## **ALERT SERVICE BULLETIN**

**407-23-133**

**SUBJECT:** HORIZONTAL STABILIZER AND CARGO HOOK  
FITTINGS – SELF LOCKING INSERTS,  
INSPECTION OF

**Figure 1 (Sheet 1 of 2) – Horizontal Stabilizer Inspection**

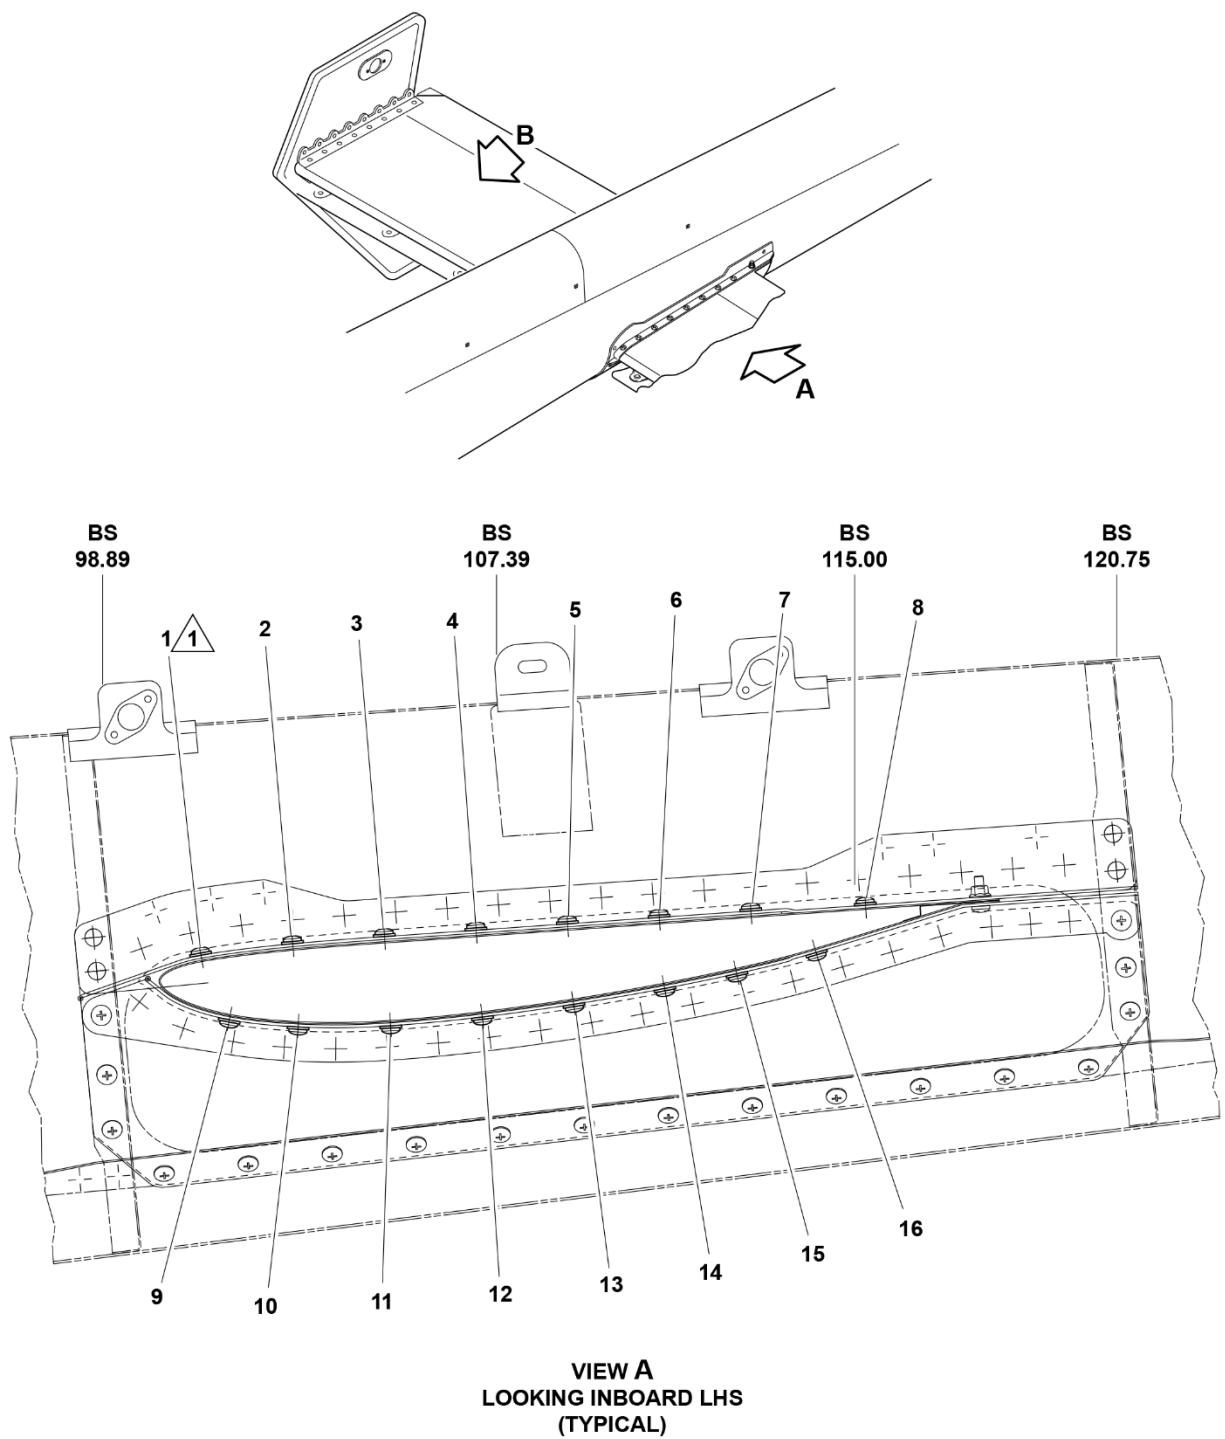
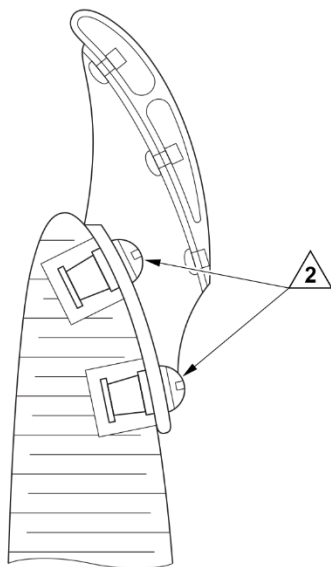
- a. Fasteners (Qty 32) attaching the horizontal stabilizer to the tailboom (Figure 1, Sheet 1).
  - b. Fasteners (Qty 16) attaching the slats to the horizontal stabilizer (Figure 1, Sheet 2).

- a. Remove the fastener and measure the tare torque of the insert (BHT-ALL-SPM Chapter 2, Section 2). The minimum tare torque of the inserts shall be 2.0 inch-pounds (0.23 Nm).

**Figure 2 – Cargo Hook Fittings Inspection**

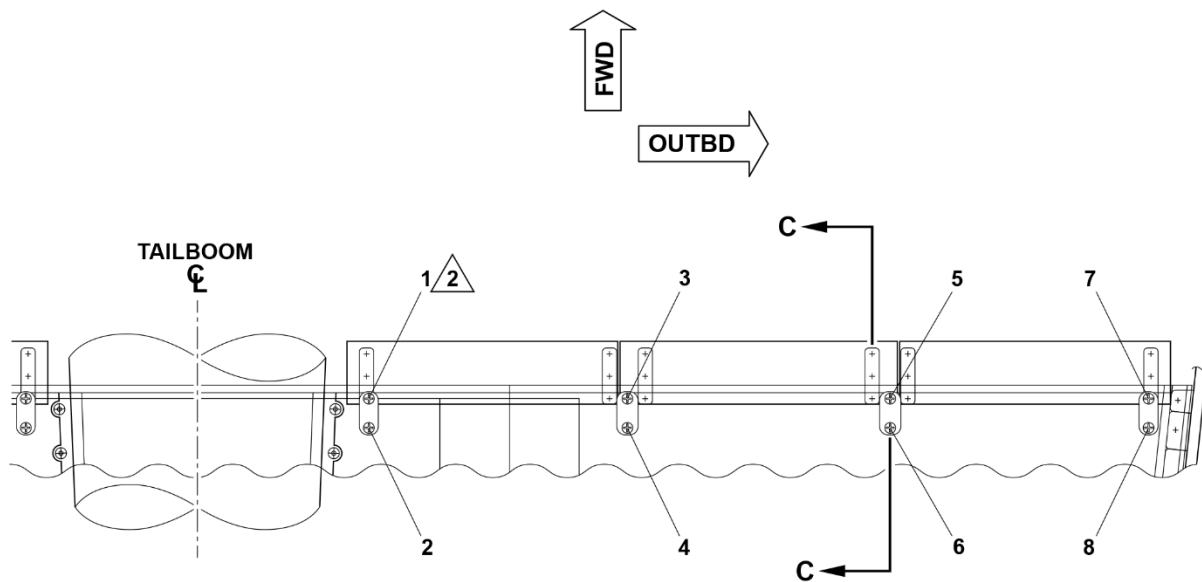
5. Verify the tare torque on the attaching fasteners (Qty 16) of the cargo hook fittings on the passenger seat bulkhead (Figure 2) as follow. Verify one fastener at a time.
  - a. Measure the tare torque of the insert (BHT-ALL-SPM Chapter 2, Section 2).
  - b. The minimum tare torque of the inserts shall be 2.0 inch-pounds (0.23 Nm).
6. If the tare torque of a specific insert does not meet the minimum value, do the following for each discrepant insert:
  - a. Remove and discard the screw installed in the discrepant insert. Retain washer if it is serviceable.
  - b. Remove and discard a screw installed in a vertically adjacent insert. Retain washer if it is serviceable.

1 Measure tare torque at 8 locations on LHS and RHS fittings.

- c. Install new bolts NAS6603H4 with two washers NAS1149D0316J at the locations where the original screws were discarded.

- d. Torque the bolts to 20 to 25 inch-pounds (2.3-2.8 Nm) plus tare torque.
  - e. Safety the new bolts together using (C-405) safety wire (BHT-ALL-SPM, Chapter 8).
- 7. Torque all other disturbed fasteners to 20 to 25 inch-pounds (2.3 to 2.8 Nm) plus tare torque.
  - 8. If inserts with tare torque below the minimum requirement are found, report the results to Product Support Engineering at [productsupport@bellflight.com](mailto:productsupport@bellflight.com).
  - 9. Make an entry in the helicopter logbook and historical service records indicating compliance with **PART II** of this Alert Service Bulletin.
